10. BENEFIT-COST ANALYSIS

Pursuant to Appendix D, 10 CFR Part 50, the Draft Environmental Statement was issued in June 1973 and was transmitted with a request for comment to the following agencies:

Our consideration of comments received and the disposition of the issues involved are reflected in part by revised text in other sections of this Final Environmental Statement and in part by the following discussion. With the exception of the applicants, the original comments are reproduced in this statement in Appendix G in order of receipt.

SUBJECT: Dresden Nuclear Power Station, Units 2 & 3 - Draft
Environmental Impact Statement

Fig. D.1. Equilibrium Temperatures and Heat Exchange Coefficients for the Chicago Region. From E. L. Thackston and F. L. Parker, "Effects of Geographical Location on Cooling Pond Requirements and Performance," Vanderbilt University, March 1971.

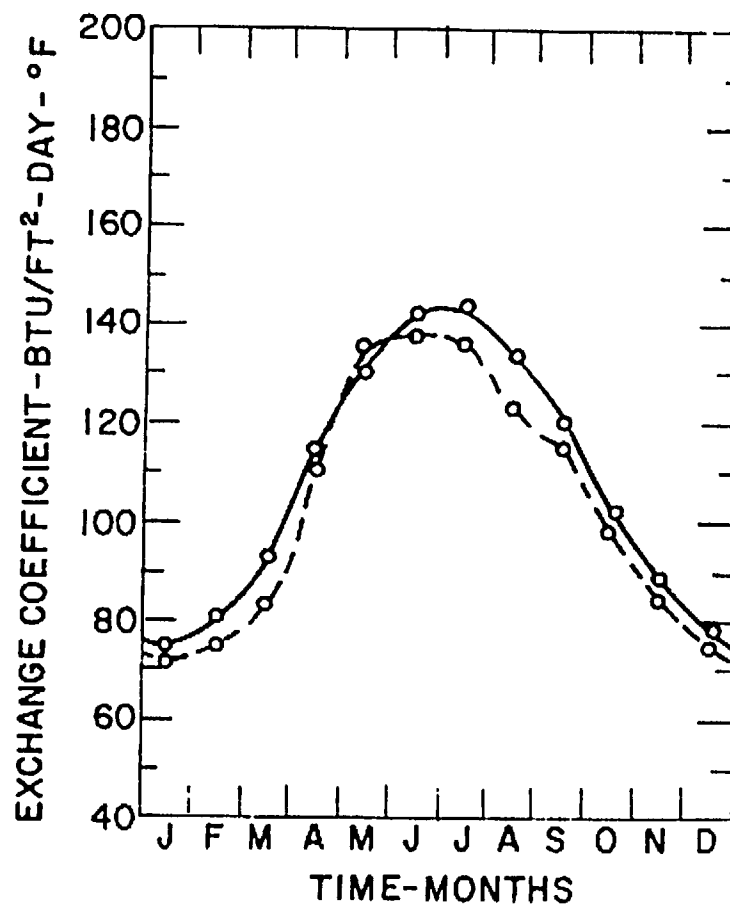
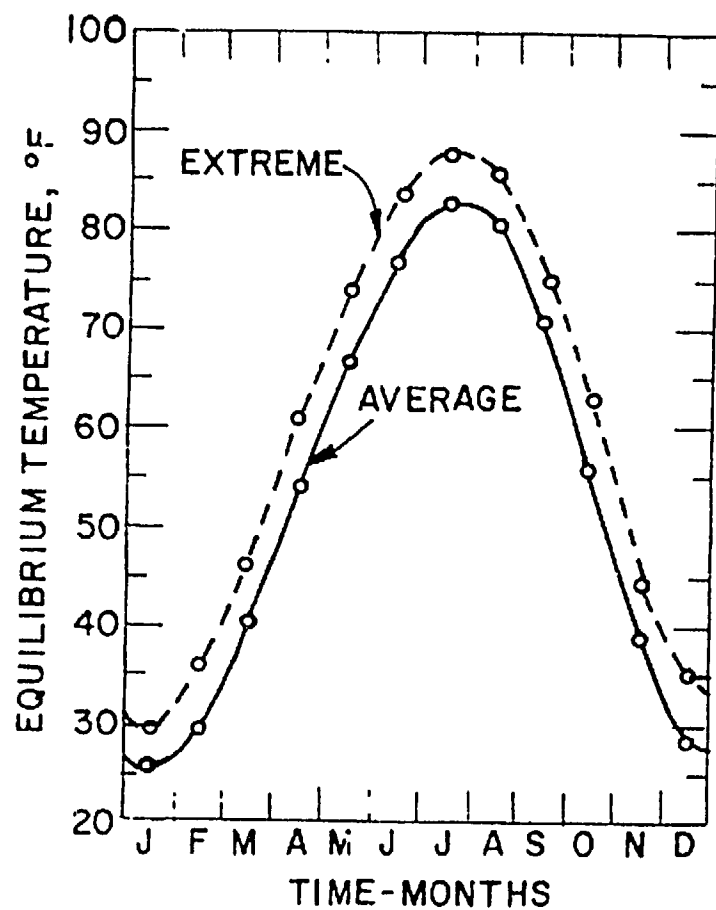
Thackston and Parker have calculated the equilibrium temperatures and heat exchange coefficients for 88 locations throughout the country.² Figure D.1 is a plot of these parameters for Chicago for the twelve months of the year. The solid curve contains the values that correspond to average meteorological conditions. The dashed curve corresponds to extreme meteorological conditions, and results from assuming that all meteorological variables are at the value which is exceeded once in ten years. The probability that all these variables are at the extremes simultaneously is small.
